Product Change Notification / ALAN-28BFQE464

CCB 5102 Final Notice: Qualification of CARC as a new assembly site for LX7167ACLD-TR and LX7167CLD-TR catalog part numbers (CPN) available in 8L WDFN (2x2x0.8mm) package.

PCN# ALAN-28BFQE464

ASAC (UDG)

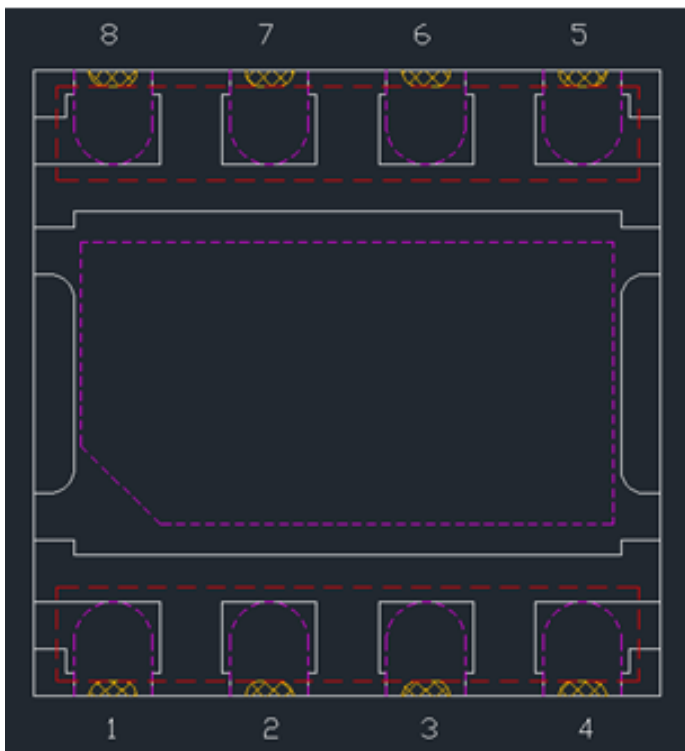
Material	C194 FH
Paddle Size	43 x 69 mil
DAP Surface Prep	Ag on lead only
Lead-lock	No

CARC

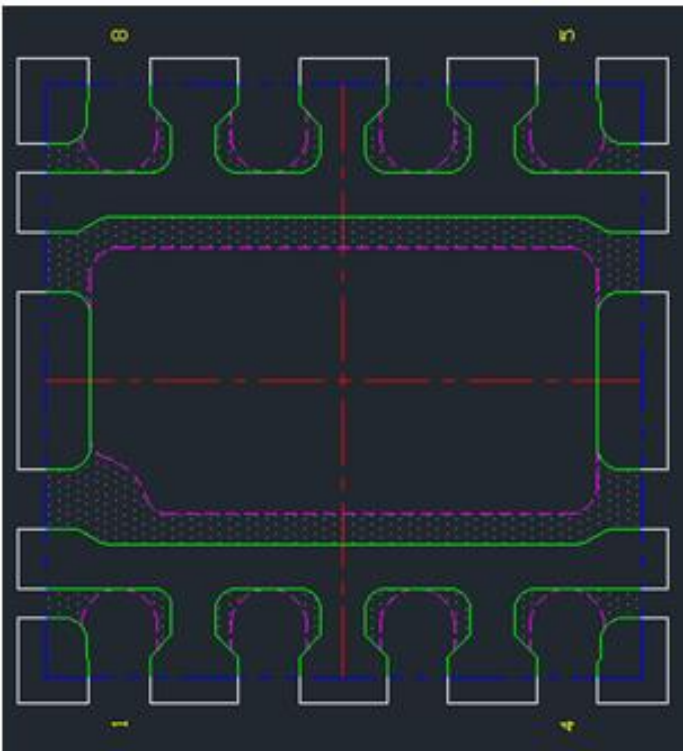
Material	C194
Paddle Size	43 x 67 mil
DAP Surface Prep	Spot Ag
Lead-lock	Half-etched
